PROJECT: WOODSPRING SUITES HOTEL – MAJOR SITE PLAN (DEVELOPMENT & DESIGN REVIEW)
Project #24-0700006

REVIEWER: VENNIS GILMORE, SENIOR PLANNER

DATE: APRIL 28, 2025

STAFF REPORT

Site Plan

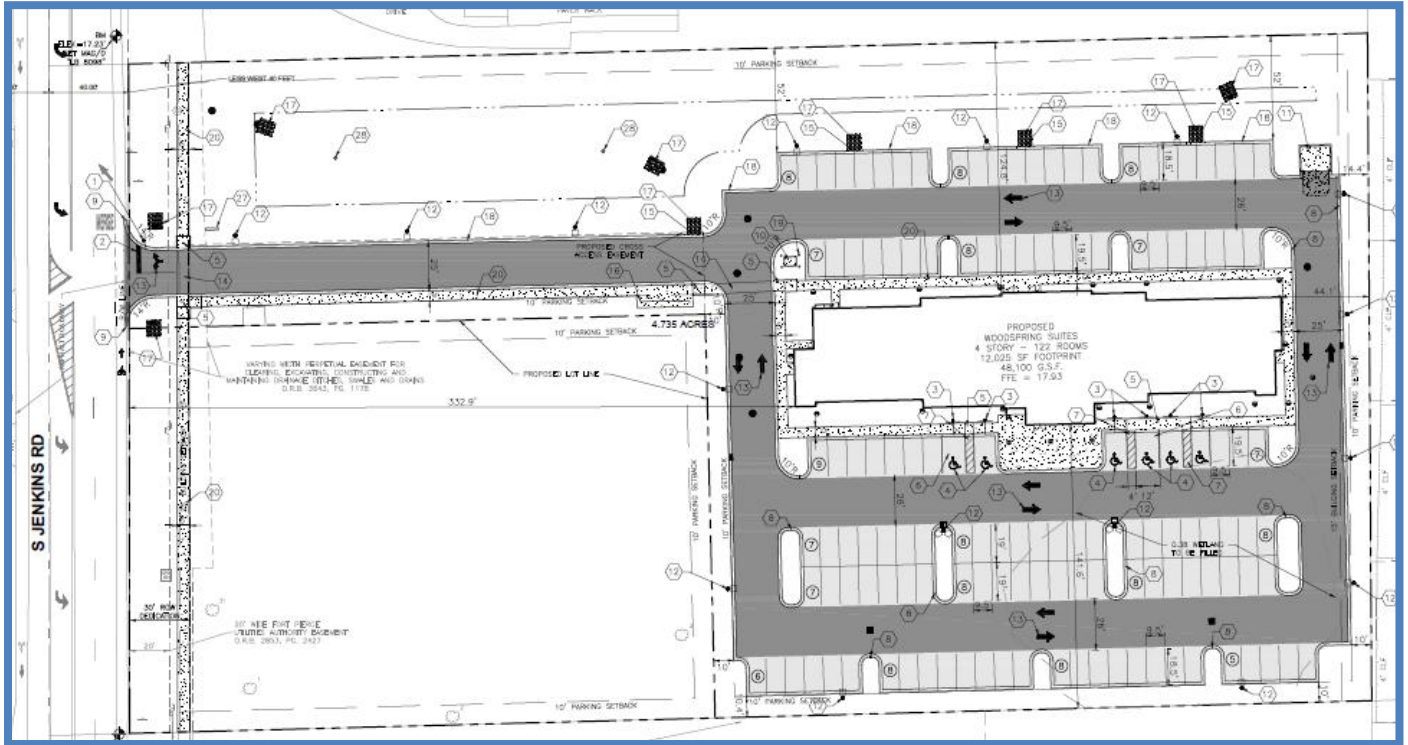
Access to the site will be facilitated off South Jenkins Road. Pavement marking improvements will be required to provide a left turn lane into the property for the southbound traffic.

Landscape Plan

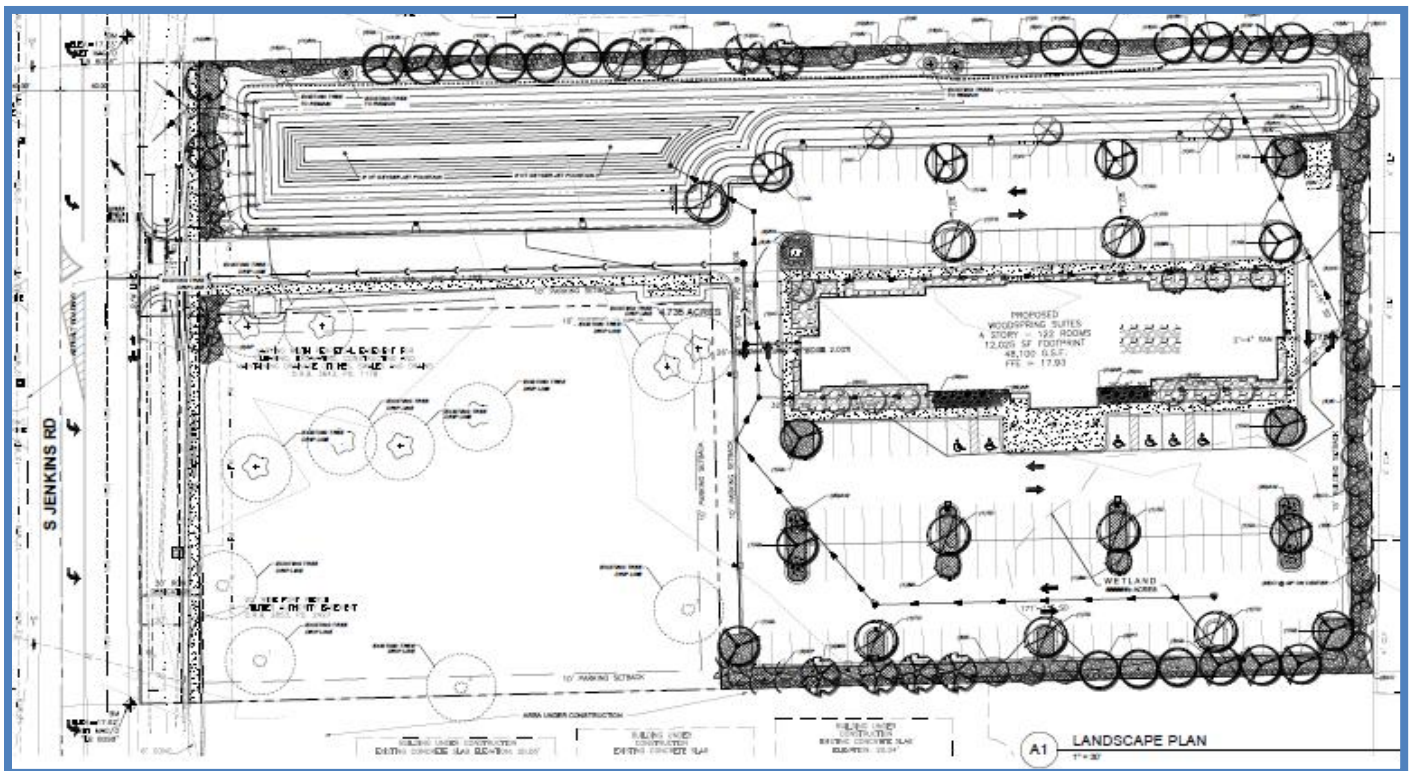
4. Install a landscaped area around the proposed monument sign base which extends a minimum distance of three (3) feet in all directions. Such landscaped area shall be completely covered by ground cover and shrubs, hedges, or similar vegetative materials.

5. Update the dumpster enclosure to the current standards by the Solid Waste Department which includes a pedestrian entrance.
6. Install a concrete, wood, or vinyl fence to buffer from the residential uses to the north and east.

7. Install a streetscape improvement such as tables or benches around or near the stormwater pond area or an outdoor recreation area.

Front Elevation

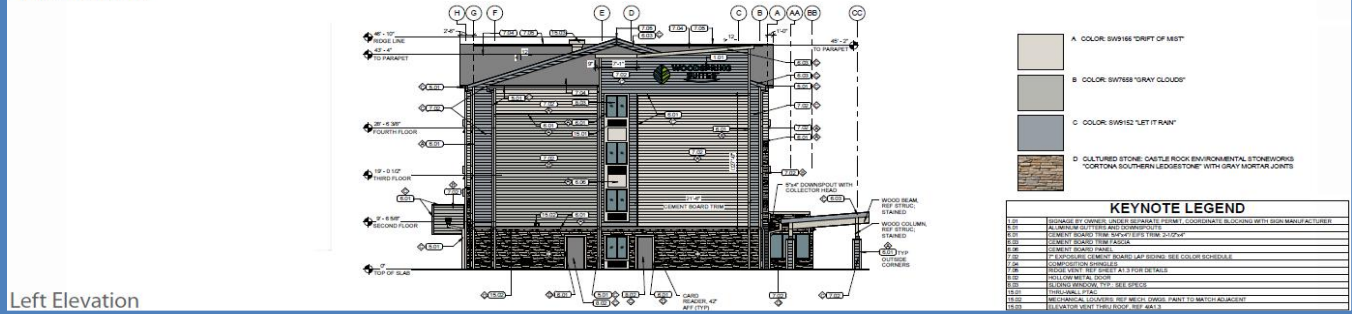
Cultured Stone will be added to areas highlighted in red
